## In the matter of Draft Laboratory Division Publication "Conducted emissions testing of transmitters with multiple outputs" (662911 D01 Multiple Transmitter out Output v01)

Ericsson respectfully submits comments and concerns in response to the Draft Laboratory Division Publication "Conducted emissions testing of transmitter with multiple outputs (draft publication 662911 D01).

Figure 1: Single transmitter with multiple outputs

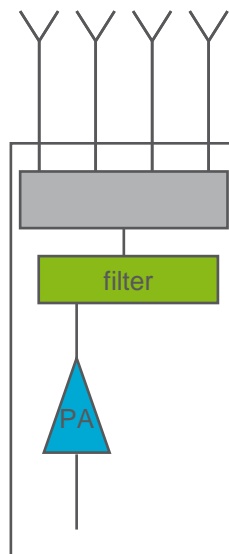
A device as shown in Figure 1, employing a single transmitter with multiple outputs which may be connected to an antenna array, is an application where the emission principles based on summation across the outputs or adjustments by  $10 \cdot \text{LOG}(N)$  should apply as stated in the draft guidance.

The case in Figure 1 is however different from 3GPP MIMO/spatial multiplexing and beam forming technologies, where each antenna is driven by a separate and independent transmitter as shown in figure 2. Such an implementation should be seen as multiple transmitters with individual outputs.

**Figure 2: Example of dedicated transmitters are used per antenna**

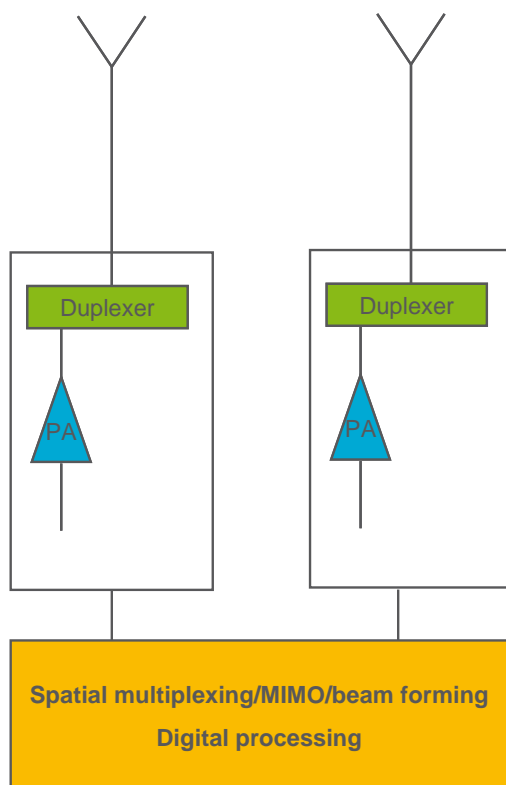
3GPP spatial multiplexing/MIMO and beam-forming technologies are purely based on digital signal processing which is applied differently for the different parallel independent transmitters. The implication is that as long as the existing rules are fulfilled at each transmitter output, the emission requirement should also be tested according to the current rules, without applying additional requirements based on summation or application of  $10 \cdot \log(N)$  across transmitter outputs.

**Figure 3** : Example for multiple independent transmitters in a device.

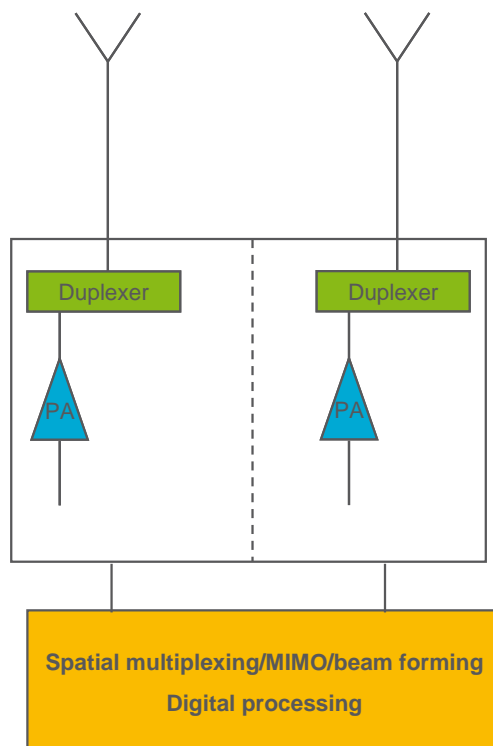
There are also device implementations with multiple independent transmitters embedded into a single device which can be deployed for spatial multiplexing/MIMO and beam-forming. In such devices, each antenna would still have dedicated independent transmitter as shown in figure 3 and should also be seen as multiple transmitters with individual outputs.

**Figure 4: Example with two scenarios in a 10 MHz license block.**

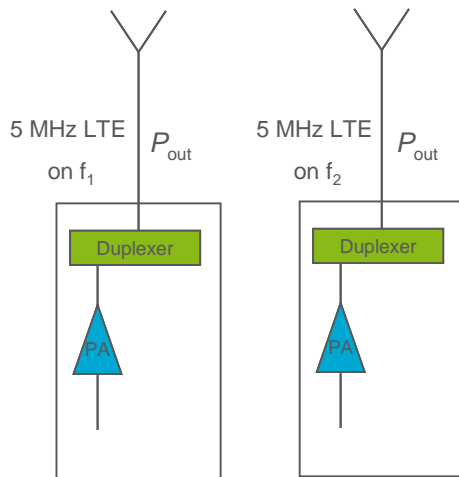
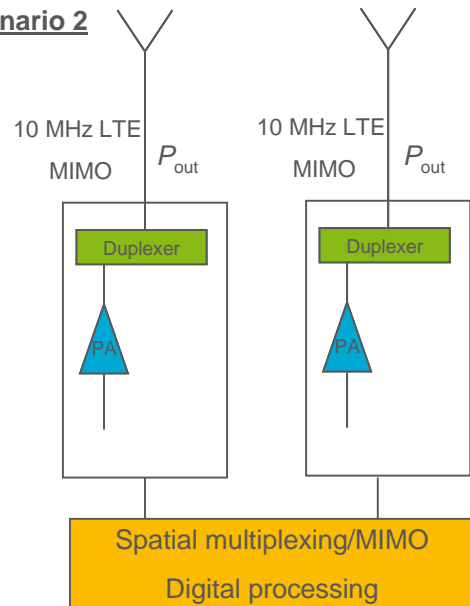
The use of spatial multiplexing/MIMO and beam-forming can be illustrated with an example for a 10 MHz licensed block, assuming the following two scenarios, as illustrated in Figure 4:

- **Scenario 1:** Two 3GPP LTE carriers of 5 MHz each are transmitted within a 10 MHz licensed block, where every carrier is handled by a separate independent transmitter.
- **Scenario 2:** One 10 MHz 3GPP LTE carrier operating in MIMO mode is transmitted within the same license block, using two separate independent transmitters.

The power transmitted per carrier is the same ( $P_{\text{out}}$ ) at each transmitter output in the two scenarios above, implying that the total power transmitted in the 10 MHz license block is also  $2 \cdot P_{\text{out}}$  for both scenarios.

For Scenario 1, the existing emission requirements apply per transmitter output. For Scenario 2 however, the proposed guidance would pose a 3 dB more stringent requirement on each transmitter. Noting that both scenarios have the same PSD characteristics, the proposed guidance based on summation or application of  $10 \cdot \text{LOG}(N)$  would create an ambiguity in the rules and also pose stricter requirements given similar circumstances, which could discriminate specific technologies and/or implementations.

Imposing summation or application of  $10 \cdot \text{LOG}(N)$  is a direct change of the emission rules per transmitter and would discriminate the 3GPP technologies identified and consequently restrict the achievable data rates by imposing unmotivated stricter emission levels.
